**Resource Consent Applications RM165114, RM165115 and RM165116 –
Accidental and overflow discharges**

Nelson Regional Sewerage Business Unit (NRSBU)

This letter provides the further information sought in your request for further information (RFI) requests of 3 May and 24 May 2016. The numbers used below correspond with the numbering used in the RFI letter.

Figure 2: Pump and backup configurations for pump-stations

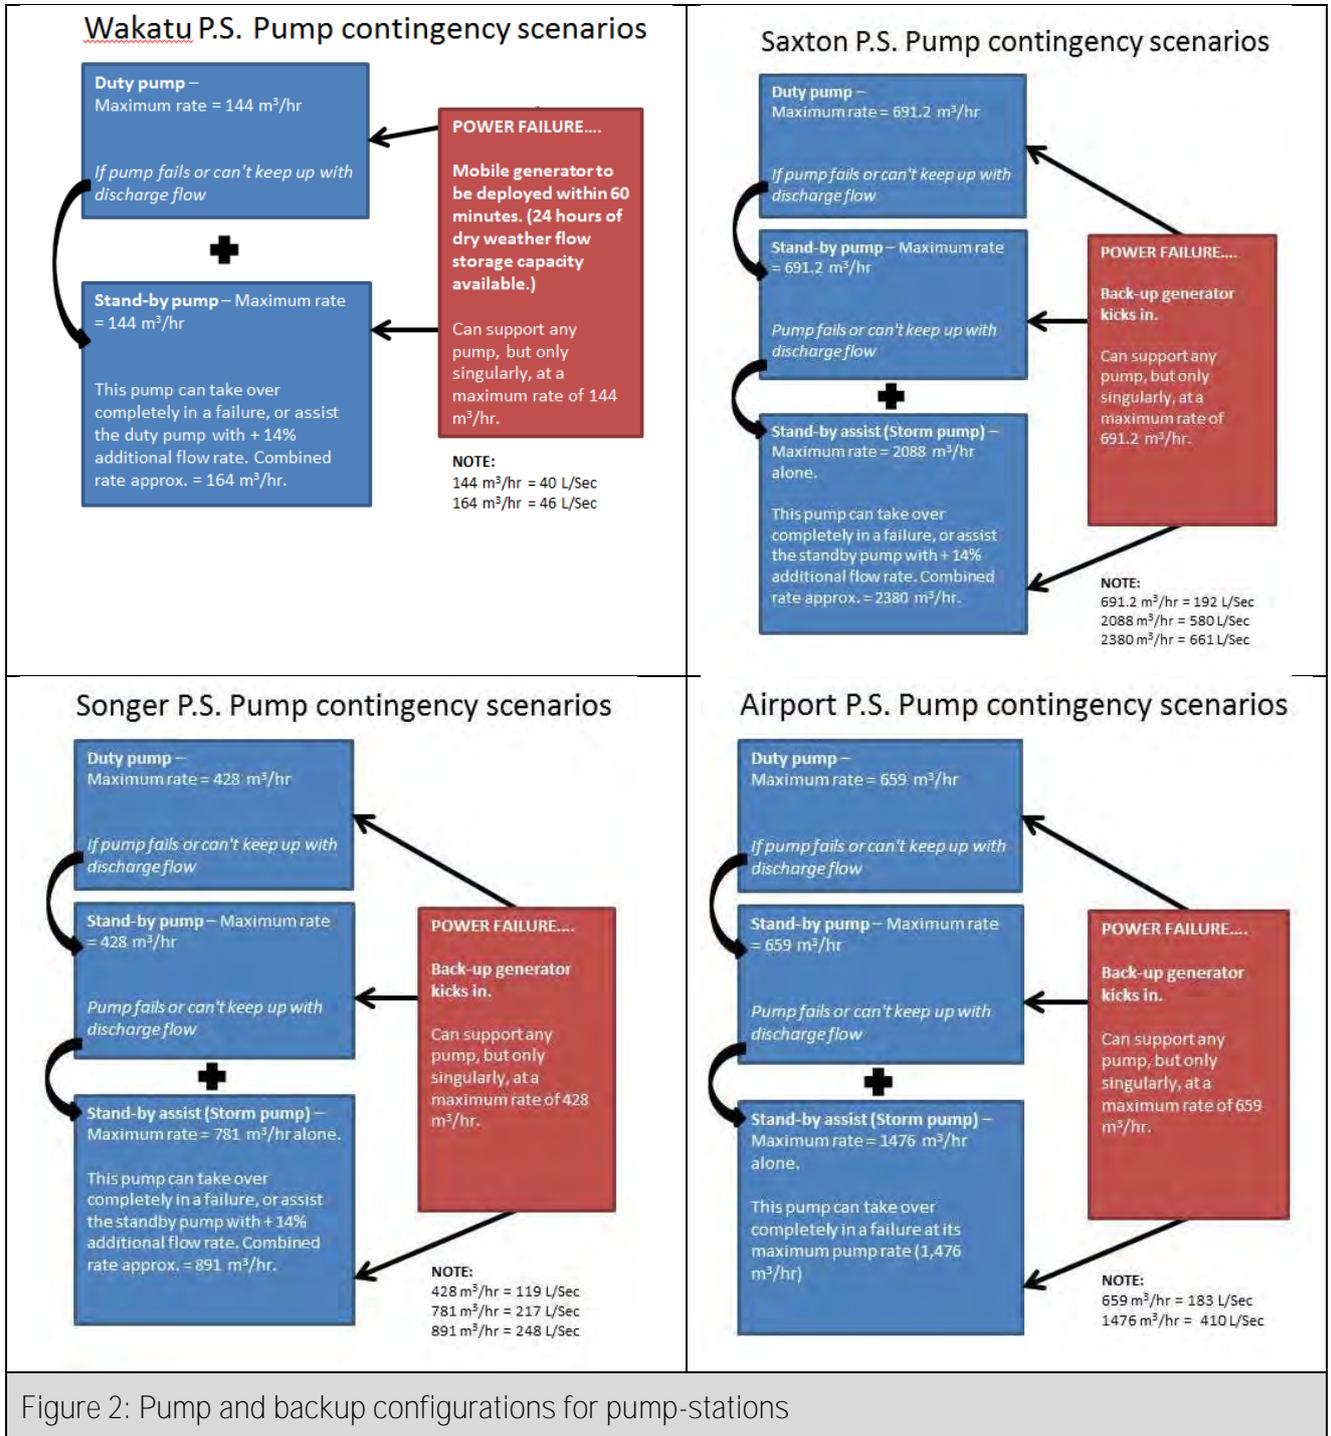
8. Update Figure 2

Figure 2 is updated as requested.
